1992 Corvette: Service Bulletin: Hood Latch Striker Bolt

Subject: HOOD LATCH STRIKER BOLT (USE PAST MODEL SERVICE PARTS)

Model and Year: 1992 Corvettes, Prior to VIN Breakpoint N5100919

Bulletin Number: 92-43-10 - (11/07/1991)

VIEW A

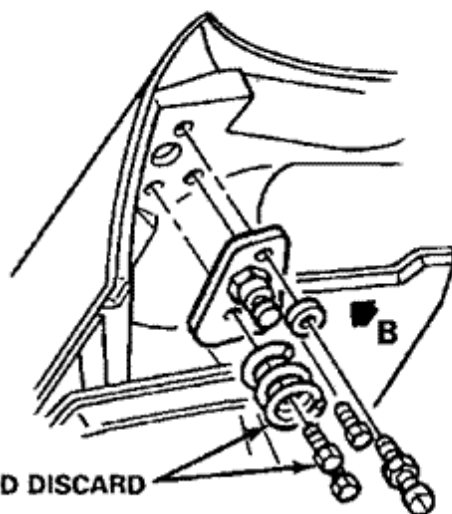
1. Raise hood to full open position. 2. Remove pop up spring and attaching bolt from bracket and discard (see View A). 3. Install new attaching bolt in position, tighten and torque to 27 N.m (20 lbs. ft.). 4. Loosen the locking nut on the striker latch bolt, remove bolt and nut from hood bracket, disassemble nut from bolt and save the nut for use on the new striker bolt. DISCARD THE ORIGINAL STRIKER BOLT. 5. Preassemble the new bolt, retainer, spring and original lock nut (see View B).

VIEW B — PRODUCTION

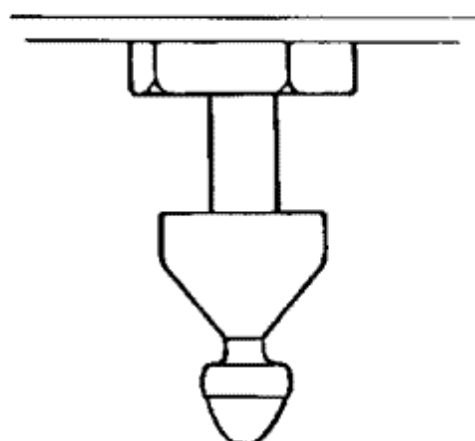
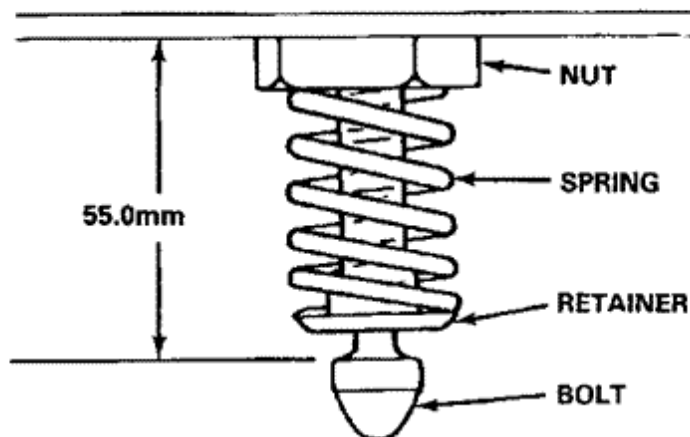
NOTE: The nut has a cavity on one side to act as spring seat.

6. Install the new striker bolt assembly to the bracket on hood, set initial

VIEW C
OUTSIDE VIEW

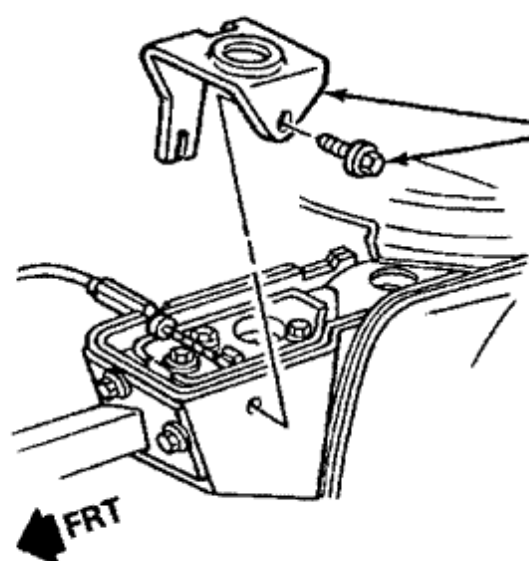
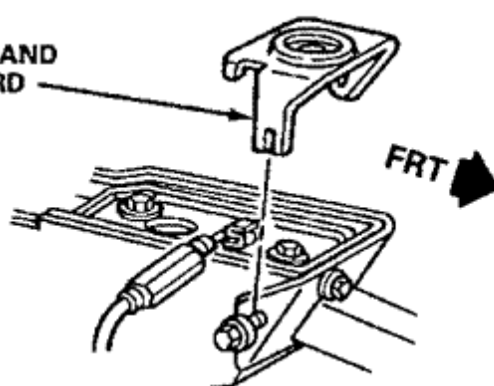
height as indicated on the illustration and tighten the locking nut. 7. Remove the outer attaching bolt for the spring seat (View C), loosen the inner attaching bolt and remove and discard the spring seat and outer attaching bolt. 8. Tighten the inner attaching bolt and torque to 25 N.m (18 lbs. ft.), see View C, inside View. 9. Carefully lower hood, check for latching and flushness conditions and adjust as required.
